Petition Number: 2022-177

From: Jake Carpenter, PE Reviewer: Travis Miller

#### **General Review Information**

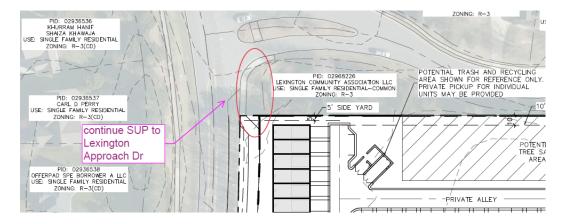
- 6. Revise site plan by removing the current public street stub to the N of the site or by revising it to be privately maintained.

7. CDOT REQUEST: Revise site plan and conditional notes to extend the shared-use path (SUP) to the north connecting to Lexington Approach Drive. Upgrade ADA ramp to match MUP width at Lexington Approach Drive.

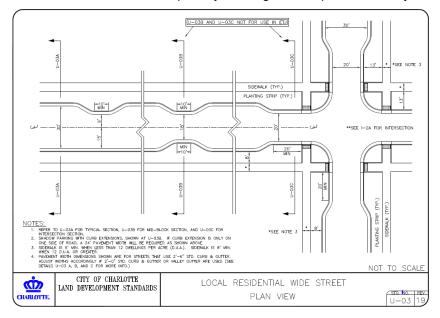
- 8. Revise site plan and conditional notes by committing to constructing a dedicated right-turn lane into the site on Mallard Creek Road with 100-feet of storage and designing the site entrance on Mallard creek to be right-in right-out in coordination with NCDOT. This right turn lane will be in addition to the added through lane that has been planned at this location that extends 1000-feet to the north of Galloway Road. Commit to coordinating improvements with current development in this location.
- 9. Outstanding comment from 02-22-23: Revise site plan and conditional note(s) to commit to constructing the internal public roadway to CLDSM standard U-03.

Clarifying comment 03-23-23: Revise site plan by labeling internal public roadway as CLDSM U-03
